## Report to the Future Melbourne Committee

### Planning Permit Application: TP-2021-28 57-59 Wakefield Road, Kensington

## DELEGATE REPORT

<b>Application number:</b>	TP-2021-28
<b>Applicant / Owner / Architect:</b>	Plan Urban / Odette Kasab / SDS Developments Pty Ltd
<b>Address:</b>	57-59 Wakefield Street, KENSINGTON VIC 3031
<b>Proposal:</b>	Development of two dwellings on the site and a car parking reduction pursuant to Clause 52.06
<b>Cost of works:</b>	\$870,000
<b>Date of application:</b>	22 January 2021
<b>Responsible officer:</b>	Michelle Fernando, Senior Urban Planner

SHADOW CALCULATIONS	
EXISTING SHADOWS	3819 m <sup>2</sup>
ADDITIONAL FENCE SHADOWING	838 m <sup>2</sup>

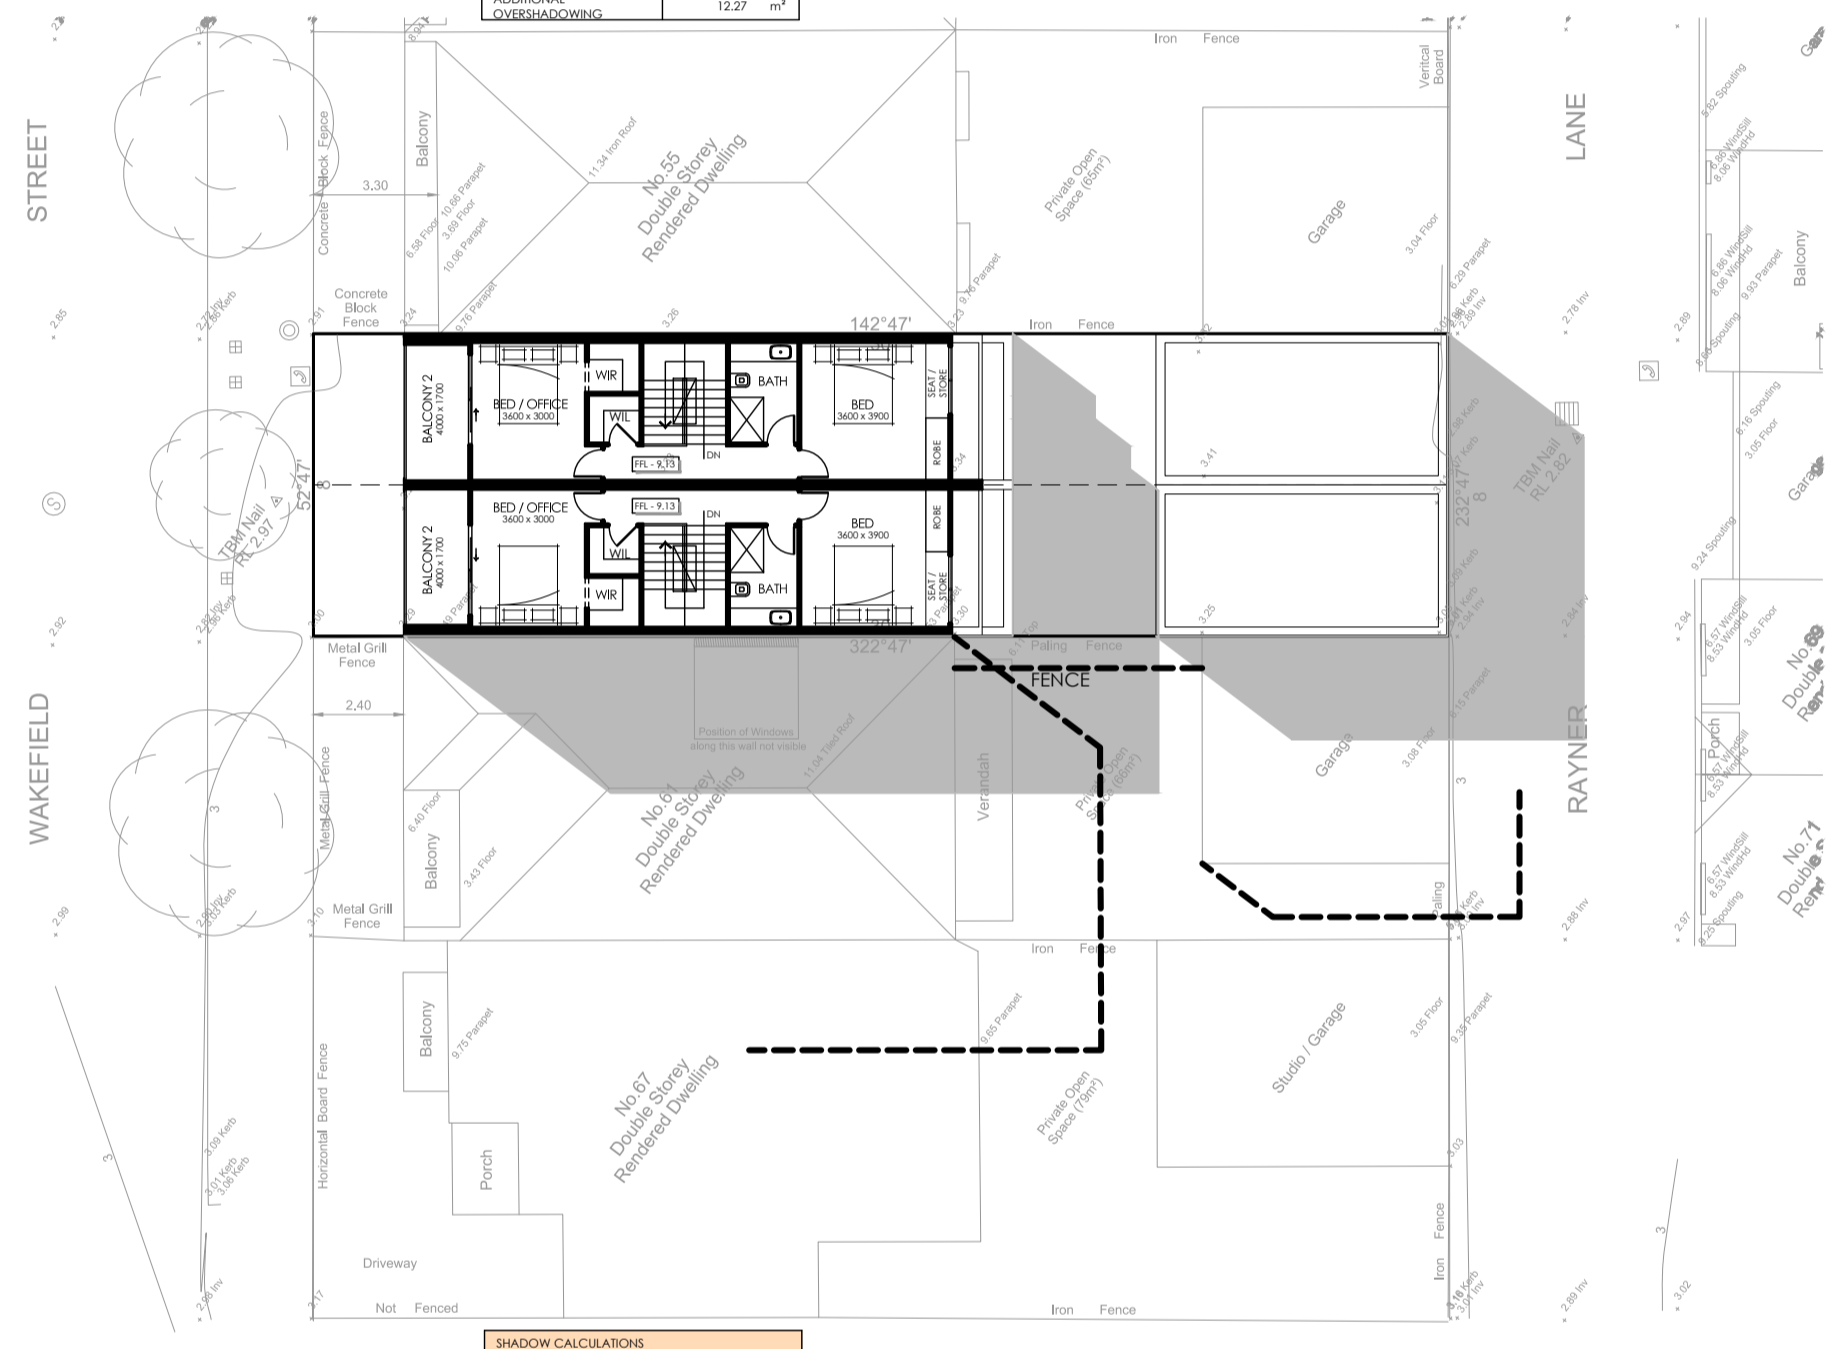
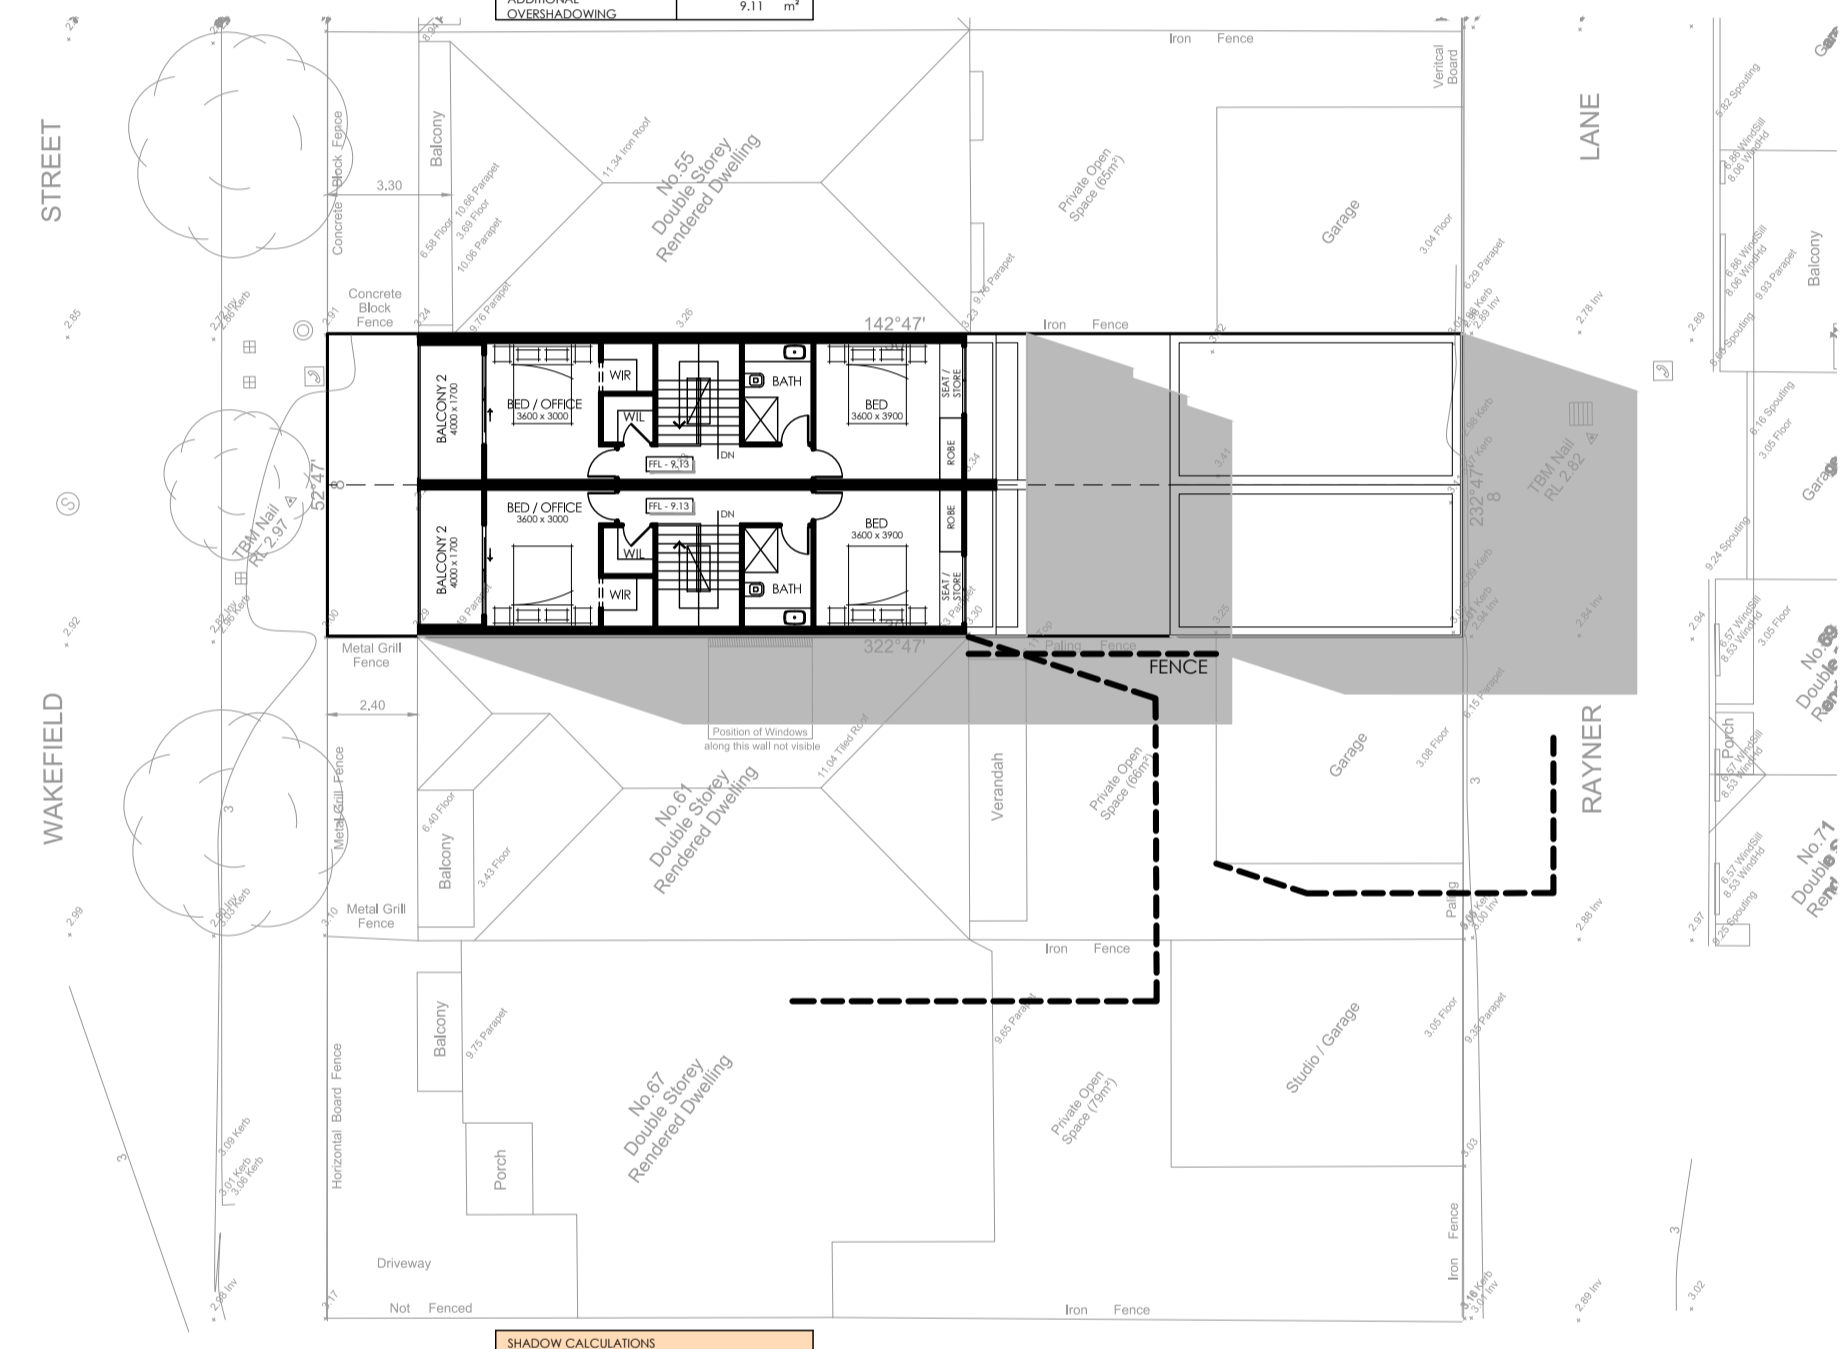
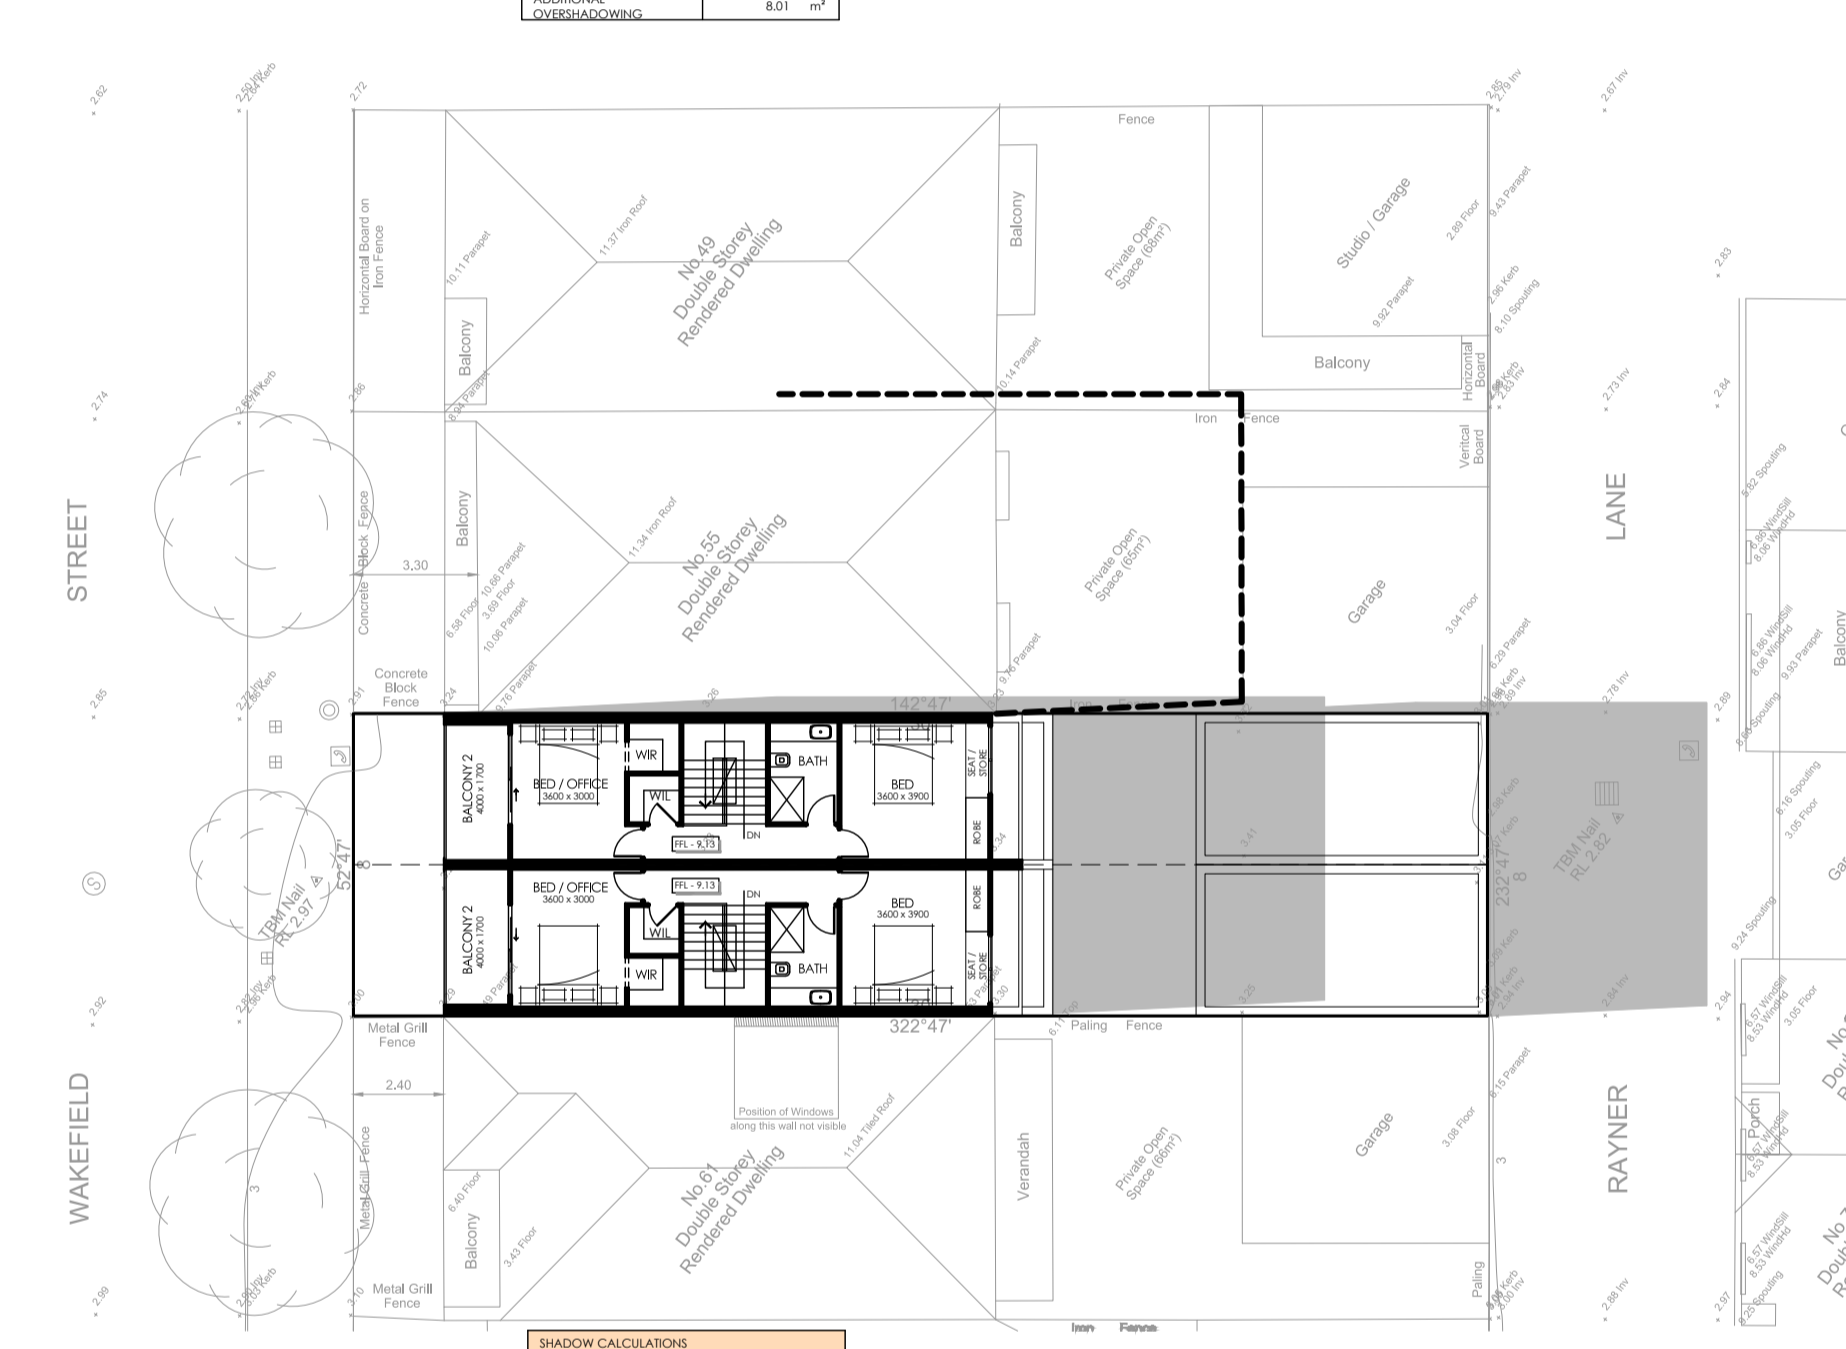
61 Wakefield Street						
	Minimum unshadowed POS required (m <sup>2</sup> )	Existing unshadowed POS (m <sup>2</sup> )	Complies?	Proposed change in shadow (m <sup>2</sup> )	Proposed sunlight (m <sup>2</sup> )	Complies?

<b>9:00 AM</b>	39	30	N	12.27	17.73	N
<b>10:00 AM</b>	39	33.75	N	9.21	24.54	N
<b>11:00 AM</b>	39	30.7	N	8.02	22.68	N
<b>12:00 PM</b>	39	21.77	N	8	13.77	N
<b>1:00 PM</b>	39	13.68	N	5.05	8.63	N
<b>2:00 PM</b>	39	3.94	N	0	3.94	N/A – No change
<b>3:00 PM</b>	39	2.96	N	0	2.96

<b>55 Wakefield Street</b>						
	Minimum unshadowed POS required (sqm)	Existing unshadowed POS (sqm)	Complies?	Proposed change in shadow (sqm)	Proposed sunlight (sqm)	Complies?
<b>9:00 AM</b>	39	31.46	N	0	31.46	N/A – No change
<b>10:00 AM</b>	39	33.98	N	0	33.98	
<b>11:00 AM</b>	39	33.94	N	0	33.94	
<b>12:00 PM</b>	39	21.28	N	0	21.28	
<b>1:00 PM</b>	39	12.59	N	0	12.59	
<b>2:00 PM</b>	39	0.53	N	0.53	0	N
<b>3:00 PM</b>	39	2.96	N	2.96	0	N

Minor errors in the plans have been noted and the applicant has provided revised shadow diagrams that correct the veranda of 61 Wakefield Street to an open pergola and height of parapet wall.

Figure 6 – Roof plan as per concept plans with ac units, provided by the applicant dated 15 June 2021

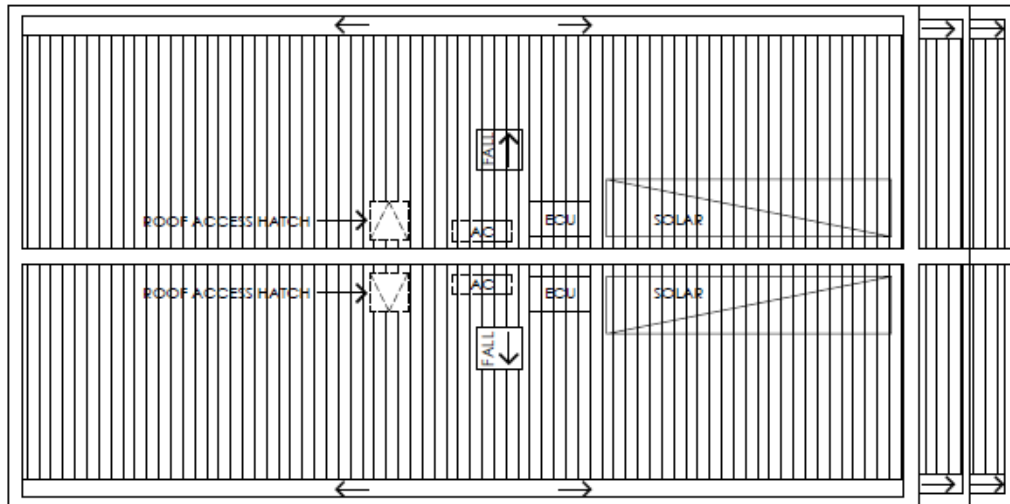
The applicant has advised that air conditioning units will be located as follows:

- Ground floor adjacent shared boundary of proposed dwellings with hot water units.
- Roof level in a central locations, as illustrated in Figure 6 below.
- Balcony of rear studios adjacent shared boundary of proposed dwellings.

The units are not immediately adjacent noise sensitive rooms on adjoining lots. This will be formalised through a condition of permit.
